UNITED STATES PATENT AND TRADEMARK OFFICE

10/507,428

ALLIOT, VINCENT MARCEL
GHISLAIN

DETAILED ACTION

Fig. 2.

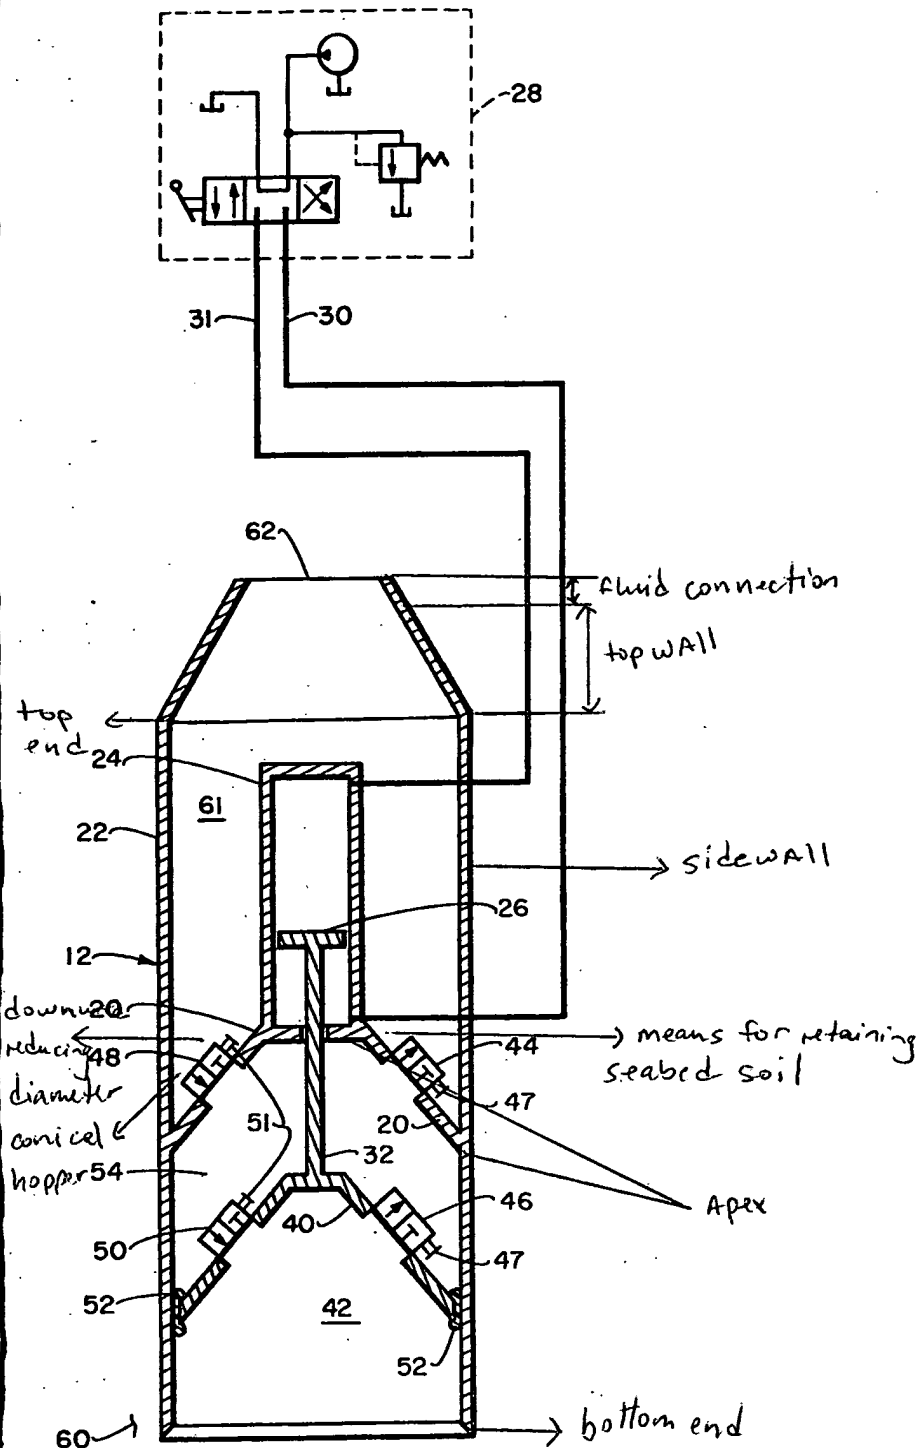
Haynes discloses a seabed anchor (see Fig. 2) in the form of a caisson (12) having a longitudinal axis and comprising a caisson side wall (see attached marked up drawing), said side wall surrounding an interior volume and having top and bottom ends (see attached marked up drawing) and, a top wall (see attached marked up drawing) substantially closing the interior volume at its upper end, while being provided with a fluid connection (see attached marked up drawing) to the interior volume, to cause fluid to be withdrawn away from an upper part of said interior volume during embedment whereby suction is applied to cause embedment of the anchor in seabed soil, a bottom edge of said side wall defining an open caisson bottom which permits the anchor to be embedded in the seabed soil in a direction generally downwardly along said longitudinal axis by penetration of said side wall edge into the soil, wherein a lower portion of said interior volume is substantially free of obstruction, and wherein means for retaining seabed soil (see attached marked up drawing) are provided in an upper portion

of said interior volume, said means for retaining seabed soil being adapted to displace, receive and retain a quantity of the seabed soil, a weight of the seabed soil retained by the means for retaining seabed soil adding to the force required to pull the embedded anchor out of the seabed when the anchor has been emplaced. (Re claim 3)

the means for retaining seabed soil comprises at least one container having an opening (44,48) arranged to admit seabed soil during embedment of the anchor in the seabed.

Re claim 4, the means for retaining seabed soil has a downwardly reducing external cross-section (see attached marked up drawing) to minimize resistance to upward movement of seabed soil past the means for retaining seabed soil during embedment of the anchor. Re claim 5, the means for retaining seabed soil comprises at least one conical hopper, having an apex oriented to penetrate the soil during embedment (see attached marked up drawing). Re claim 6, the means for retaining seabed soil is located entirely within the interior volume of the caisson. Re claim 17, the fluid connection is disposed on the top wall (see attached marked up drawing) and communicates with the interior volume, and a pump (24,26,32) connected to the fluid connection (via member 22) thereby facilitating the fluid to be withdrawn away from the interior volume.

5. Applicant's arguments filed 10/5/07 have been fully considered but they are not persuasive. Applicant argues that Haynes '046 does not teach "fluid connection". The examiner disagrees. See attached marked up Figure 2. Applicant argues that Haynes '046 fails to teach "means for retaining seabed soil in the upper portion of the interior volume". The examiner disagrees. See attached marked up Figure 2, the "means for retaining seabed soil" is considered to be in the upper portion. Applicant argues that claim 4 is not taught. The examiner disagrees. See attached marked up Figure 2, wherein the cross-section reduces downwardly. Applicant argues that the check valves dictate for the cavities to increase. This is not found persuasive. See attached Figure 2, wherein the cross-section reduces downwardly. Applicant argues that Haynes '046 does not teach a pump to be connected to the fluid connection located on the top wall. The examiner disagrees. The fluid connection is disposed on the top wall (see attached marked up drawing) and communicates with the interior volume, and a pump (24,26,32)

connected to the fluid connection (via member 22) thereby facilitating the fluid to be withdrawn away from the interior volume. Applicant argues that there is no basis to combine Haynes '046 and Haynes '721. The examiner disagrees. Haynes '046 teaches a pump means for installing a frame/corer. Haynes '721 teaches a pump means for installing a gravity base. Therefore, it is obvious to modify Haynes '046 by substituting the gravity base as taught by Haynes '721 for the frame/corer structure disclosed by Haynes '046 in order to provide alternative use of the pumping system.
